Keweenaw Mountain Lodge Application for Dark Sky Park Designation Version: 3.0 Change Log

Date: December 15, 2021

The following is a summary of the changes that were made between version 2.1 and version 3.0 of this application.

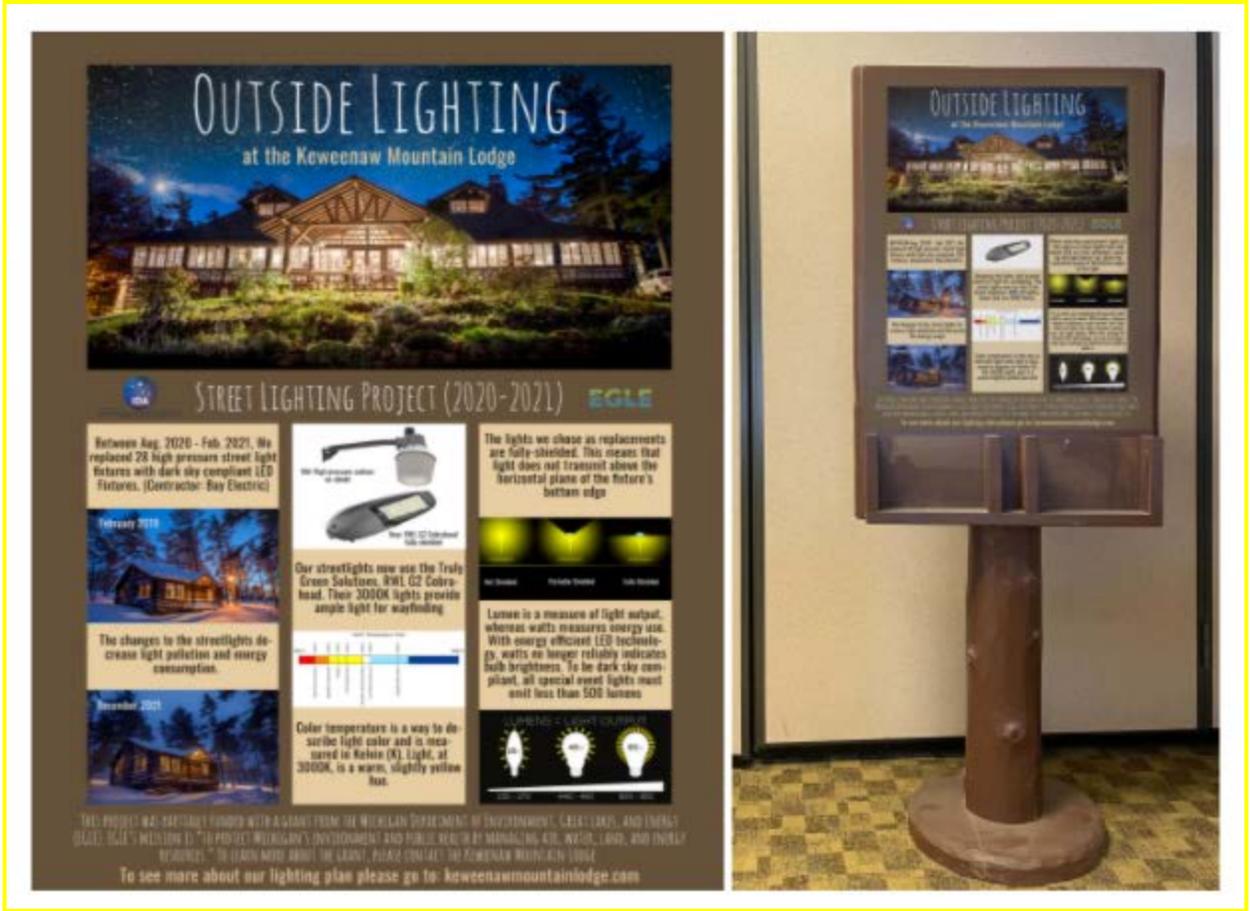
1. I would like to see more detail in how you are providing public interpretation for your street light project. The webcams and the blog post are a great start, but do guests know to pay attention to the lights while on site? In your materials, can you provide details of the specifications of choosing the best lighting fixture (warm CCT, shielding, targeting, did you include any adaptive controls like dimmers or timers, etc.)? Maybe talk a bit more about the grant you received from the EGLE grant, and if it is possible for others to apply, would you be able to provide some guidance for that resource? Can these materials be presented in an interpretive sign, brochures, etc. for those who are at the facility? The main point is we want a Park's visitors to see and feel dark-sky friendly lighting, so it is just as important that they experience and learn from your fixtures as much as it is to see the night sky.

We have now designed an infographic sign that can hang at the property and visitors can learn about the street light project we did in 2020-2021 -- as it relates to lighting and energy efficiency. We have provided images of that sign in the application. As well, an image of the sign is provided below.

So we are able to provide others information about how we went through the program, and can help them if they decide to apply for the grant. In the infographic sign that we have designed to highlight the Outside Lighting - Street Light Project (2020-2021), we mention that.
